Our Ref: 115146.04. L02b

## **TARONGA TIN MINE STAGE 1 EIS - WATER BALANCE MODELLING CLARIFICATION**

Aus Tin Mining Limited (Aus Tin) received a request for further EIS clarification from the Director of Development, Planning & Regulatory Services of the New South Wales EPA via email on 30 October 2017 in relation to the proposed Taronga Tin Mine Development. This letter provides a response to the points raised in Attachment A of the EPA request, relating to the following items:

**Plate 1  
Water Balance Model Rainfall Data**

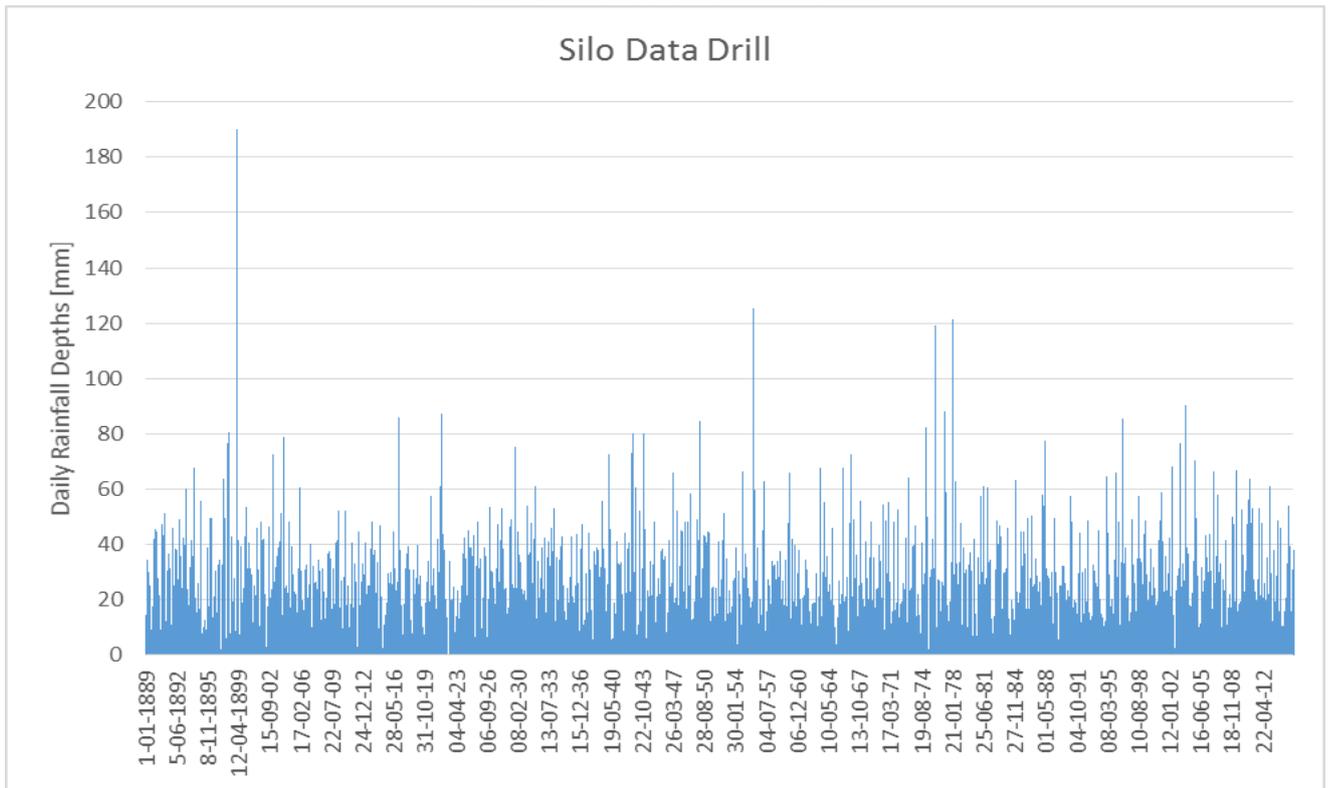
11. *The proponent must provide results from water-balance modelling with a daily time-step over an appropriate period with a climatic sequence that includes average, wet and dry rainfall years to estimate the potential annual overflow frequency. The proponent should address, but not be limited to the following issues:*

The input climate data therefore considers the full range of climatic sequences available within the historical record. The daily rainfall (mm/day) records as sourced from SILO is presented graphically in **Plate 1**.

Based on the above modelling period, the climatic data record (SILO Data Drill) was sampled for each possible sequence commencing from 1 April, providing a Monte Carlo risk simulation for the WBM to assess the performance of the proposed site water management infrastructure under all available climatic sequences. This Monte Carlo simulation is in accordance with procedures described in Australian Rainfall and Runoff Book IV (Pilgrim et al, 1987) and provides assessment of the proposed site infrastructure up to a 1 in 200 Annual Exceedance Probability (0.005 AEP, or 200 Year Average Recurrence Interval).

**Plate 2  
Site Water Management Flowchart**

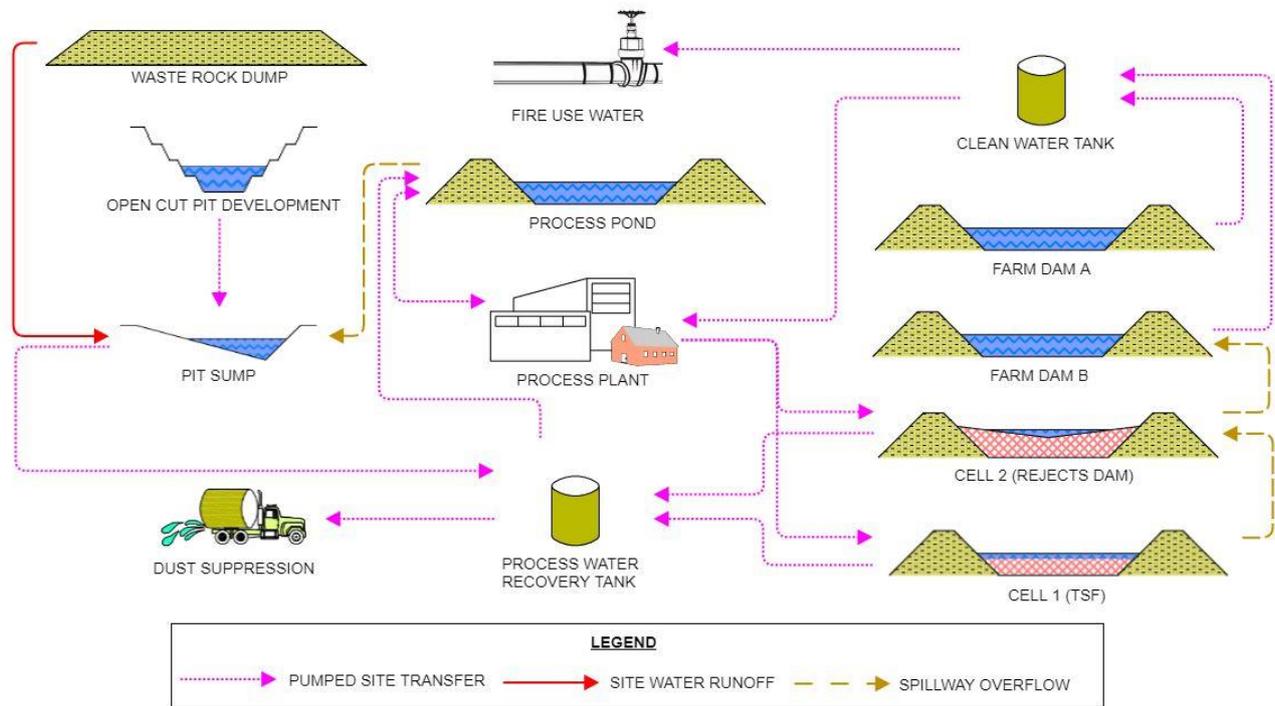
14. *The proponent must clarify sizing requirements of each water control and interactions between each element and justify sizing based on the impact assessment.*

The proposed site water management system (see Plate 2) aims to control the water levels in the TSF (Cell 1 and Cell 2) such that the water cover is maintained and that process water is sourced when available. The capacity of the TSF (including the tailings) and the pump rates (at a nominal rate of 30L/s for all site transfers) were adopted to limit the risk of uncontrolled release of mine affected water.

It is proposed that the TSF Cell 2 will not be filled beyond the maximum operating level during its operational life, to minimise spill risk. TSF Cell 2 is proposed to have sufficient capacity to store rejects and associated water, as well as provide flood capacity, as follows:

- Rejects Storage: 214.2ML
- Operational decant pond allowance: 10ML
- Total Freeboard, consisting of:
  - (1) Portion of Total Freeboard below FSL (Environmental Freeboard): 9.7ML; and
  - (2) Portion of Total Freeboard above FSL: 1m of vertical freeboard between FSL and the dam crest, in combination with the spillway, provides sufficient capacity for the Rejects Dam to pass the spillway design flood, which is a  $10^{-4}$  Annual Exceedance Probability (AEP) flood event.
